November 29, 2022

**RE: SAC Music Hall and Performing Arts (P20-041) Initial Study/Mitigated Negative Declaration**

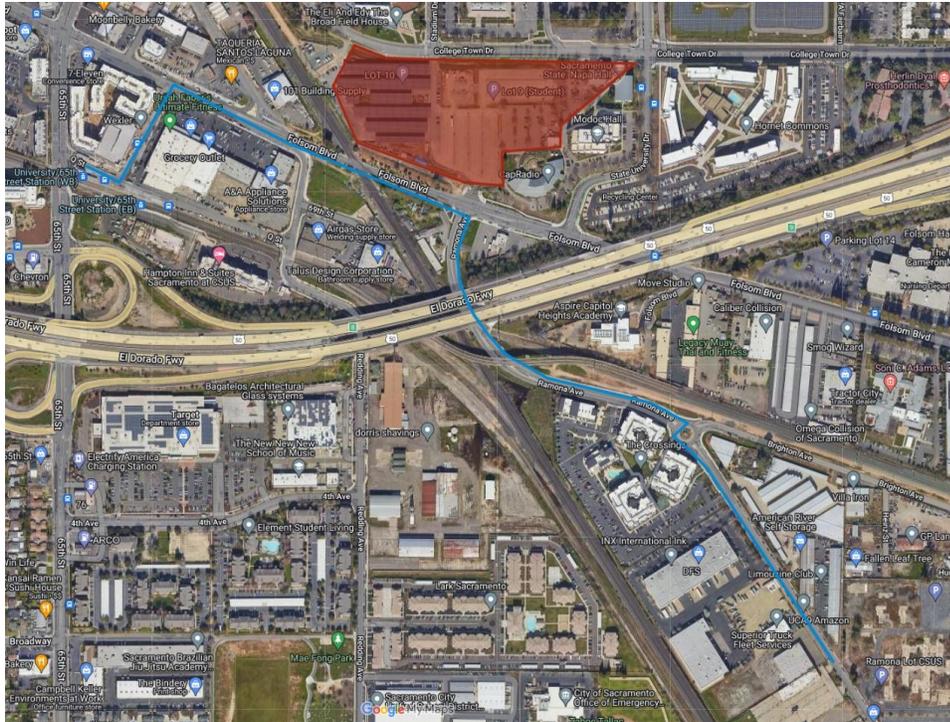
Another opportunity that should be explored is a collaborative partnership to use the auxiliary parking facilities at the southern end of the CSUS campus nearest to the Folsom Boulevard and Ramona Road intersection (red shaded area in image below). This would help to utilize lots while demand from students is lower and fill it with the evening demand of venue patrons. Coordinated shuttle services should be considered in conjunction with this strategy. In addition, this reduces the total walking distance to .75 miles using Lot 9 as a starting point. Nearby transit light rail stations are 1 mile to the 65<sup>th</sup> station when traveling along Folsom Boulevard, from which a continuous sidewalk network exists (blue line in image below) or .7 miles from Power Inn light rail station.
